RIVERWOOD ESTATES SUBDIVISION, PHASE ONE B

APPLICATION NUMBER 9 DATE August 16, 2007

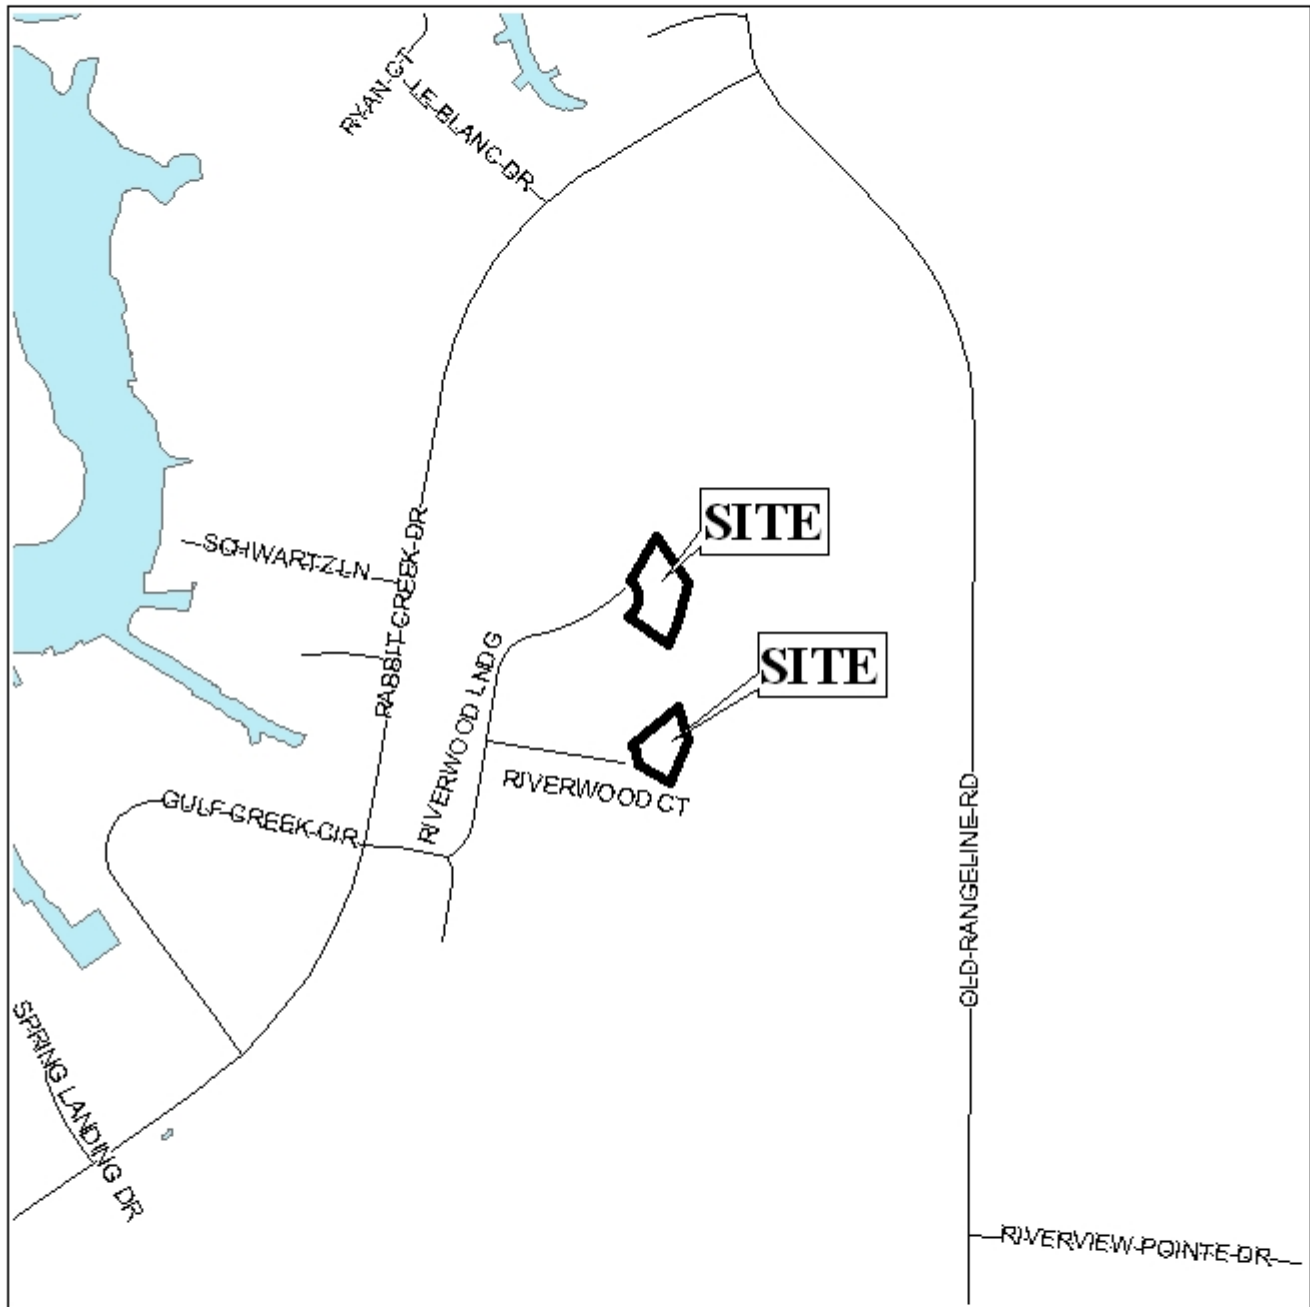
- 1) Proposed Lots 49 and 50 will not meet the minimum area requirements, exclusive of wetlands.

The revised plat shows the same lot configuration, but additionally includes the fact that the wetlands have been mitigated for each lot per U.S. Army Corps of Engineers permit number SAM-2005-4182. With mitigation, all lots will meet the minimum area requirements of the Subdivision Regulations.

Based upon the revised plat, this application is recommended for Tentative Approval, subject to the following conditions:

- 1) placement of a note on the plat stating that each lot is limited to one curb-cut, with the size, design and location to be approved by Mobile County Engineering Department;*

- 2) placement of a note on the plat stating that the development will be designed to comply with the storm water detention and drainage facility requirements of the City of Mobile storm water and flood control ordinances, and requiring submission of certification from a licensed engineer certifying that the design complies with the storm water detention and drainage facility requirements of the City of Mobile storm water and flood control ordinances prior to the issuance of any permits. Certification is to be submitted to the Planning Section of Urban Development and County Engineering.; and*

- 3) placement of a note on the final plat stating that any lots which are developed commercially and adjoin residentially developed property must provide a buffer, in compliance with Section V.A.7 of the Subdivision Regulations.*
